REGIONAL REVIEW NOTICE

ARC REVIEW CODE: R905211

Name of Proposal: Corner Market Development

Submitting Local Government: City of Conyers

GRTA Site Plan DRI No. 1970

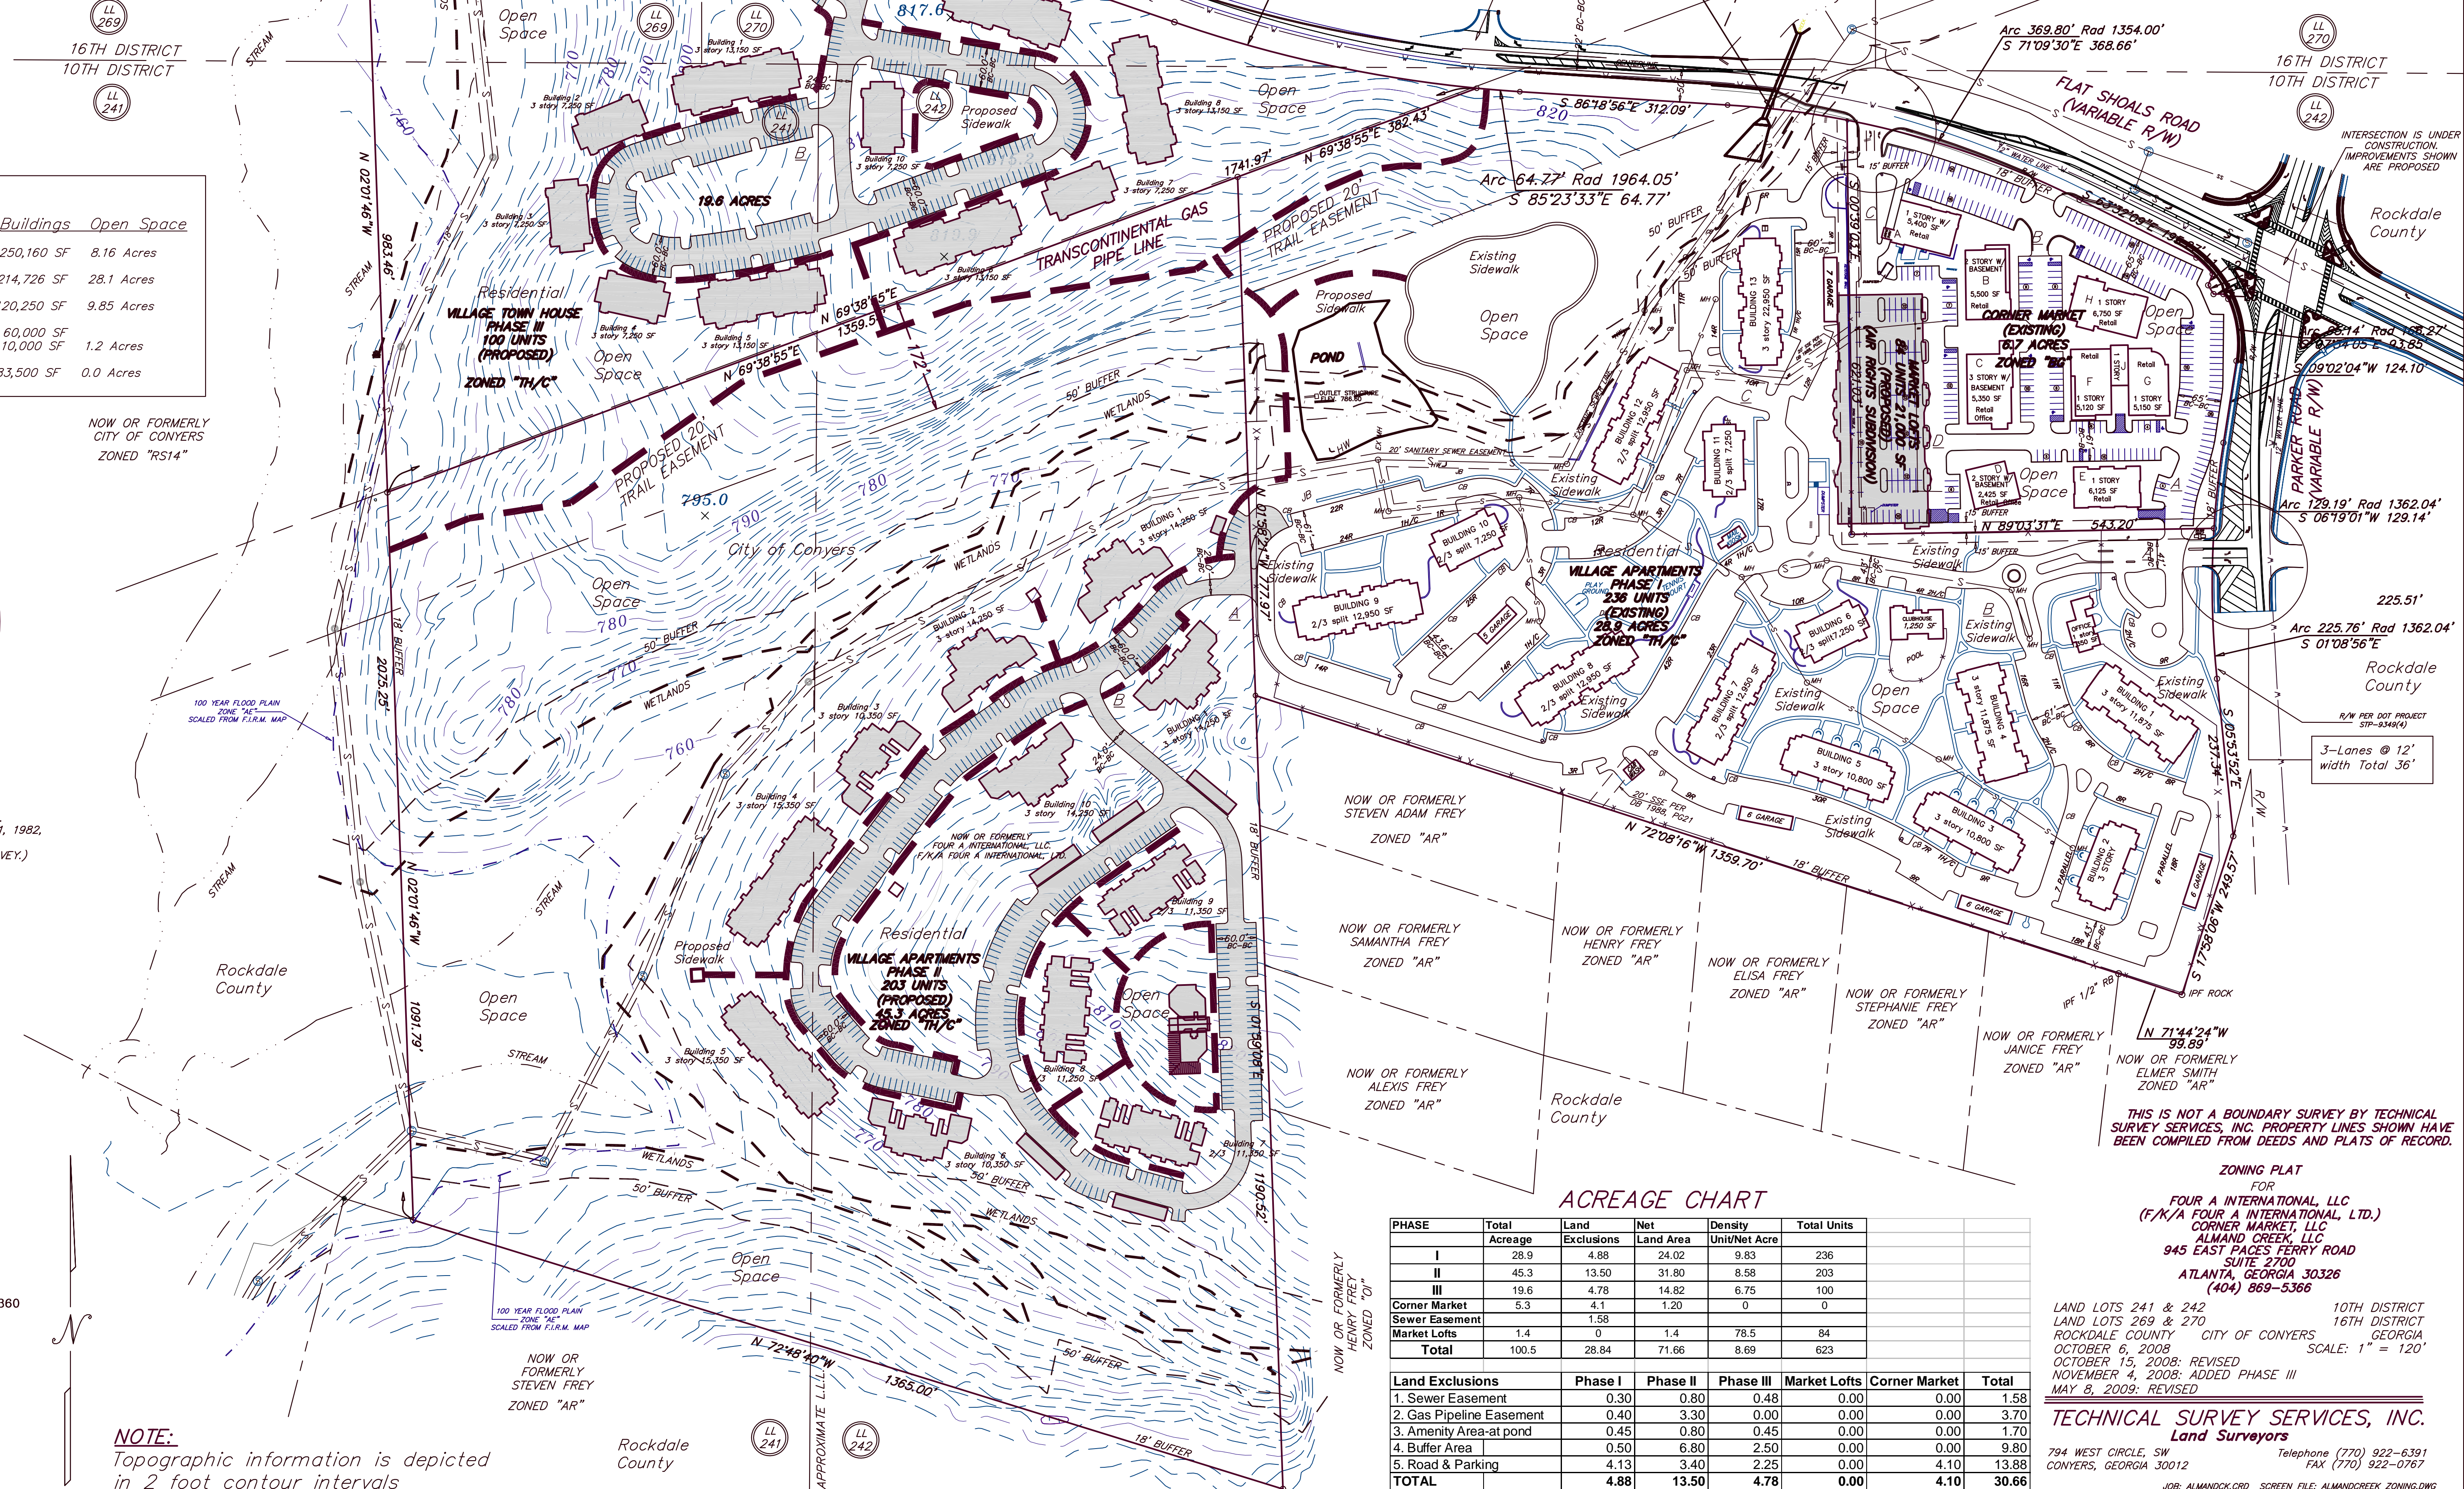
The developer should plan more direct access and better connectivity within the site between the main portion of the development and the townhouses in phase III. This could be accomplished by adding a drive between the two sections and/or creating more direct bicycle and pedestrian access.

Sidewalks are not shown on the site plan as existing or proposed along Flat Shoals Road or Parker Road. To create the opportunity for residents and visitors of this site as well as the surrounding area to walk rather than drive, ARC strongly recommends that sidewalks be included.

According to ARC's Regional Bicycle Transportation and Pedestrian Walkways Plan, multi-use trails should be 10'to 15' wide in order to safely accommodate two way traffic for both bicyclists and pedestrians. Anything less than 10' has the potential to create major safety issues for all users. It is recommended that the developer review ARC's Regional Bicycle Transportation and Pedestrian Walkways Plan for recommended construction of multi-use path facilities.

The property is in the South River watershed, which is not a water supply watershed in the Atlanta Region. The project site plan shows two unnamed tributaries of Almand Creek crossing the project property. The plans show 50-foot buffers in the areas of new construction but no additional 25-foot impervious setbacks are shown, which are also required under the City of Conyers Riparian Buffer Protection Ordinance. Any intrusions into the buffer or setback that are not allowed under the City ordinance will require variances as provided in the ordinance.
